Amendment No. 1 to Clean Water Act Section 401 Water Quality Certification No. R9-2016-0145

PROJECT: Berths V and VI Fender System Replacement Project Certification Number R9-2016-0145 WDID: 9 000003062

General Dynamics NASSCO Fender System and Pile Replacement at Berth II Project Description

Figure 3. Project Map.

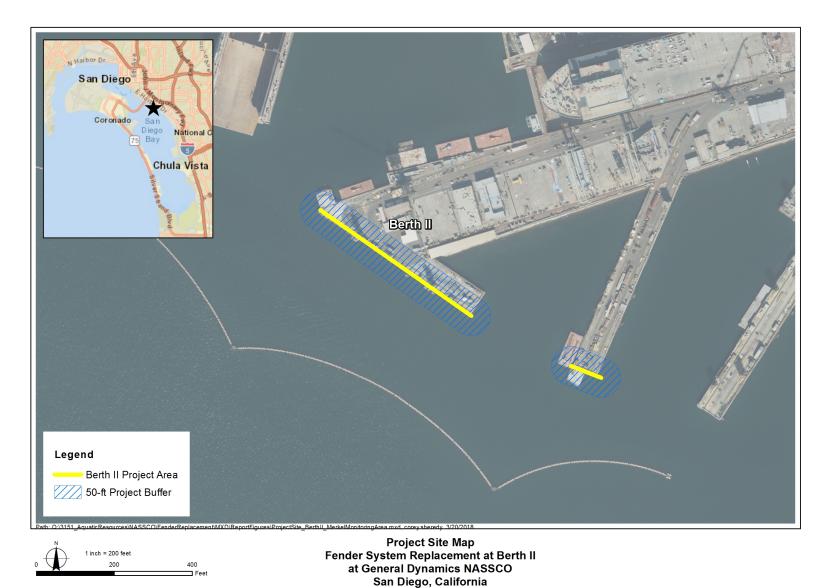
Attachment 2. Project Location Maps, the cover page is modified as follows and the attached Figure 3 is added to end of Attachment 2:

Note: Amendment request pertains to Berth II only

Figure 8. Pile Replacement Schematic for Berth II.

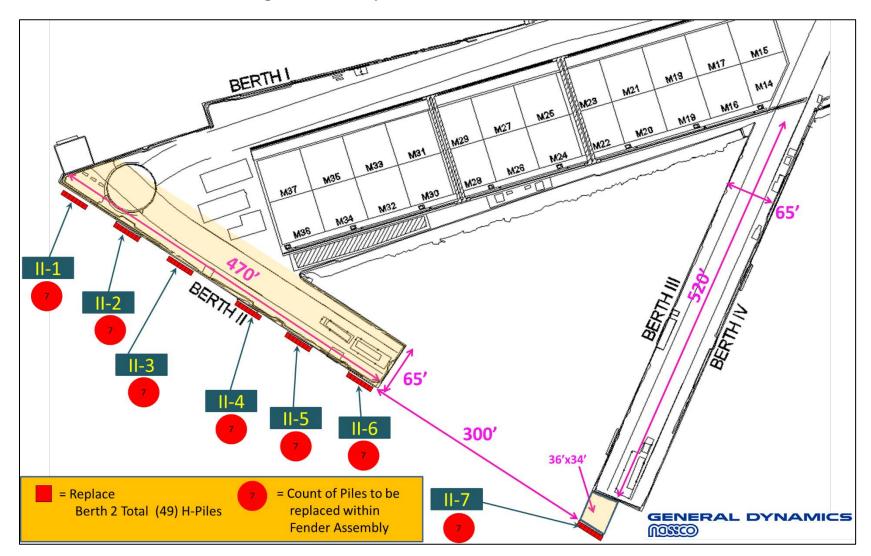
Figure 1 – Project Location Regional Map Figure 2 – Project Location Overview Map Figure 3 – Project Map Attachment 3. Project Site Plans, the cover page is modified as follows and the attached Figure 8 is added to end of Attachment 3:

Figure 8 – Piles Replacement Schematic for Berths II
